BS-23

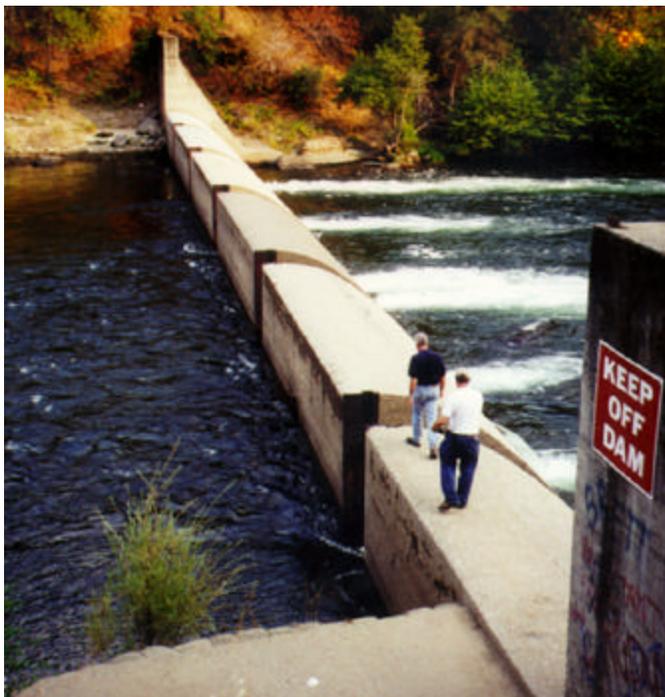
Sign has faded and been vandalized. Warning text is well grouped and stated, but disrepair detracts from effectiveness.

Replace or repair, and assess need for more frequent maintenance or anti-vandalism measures.
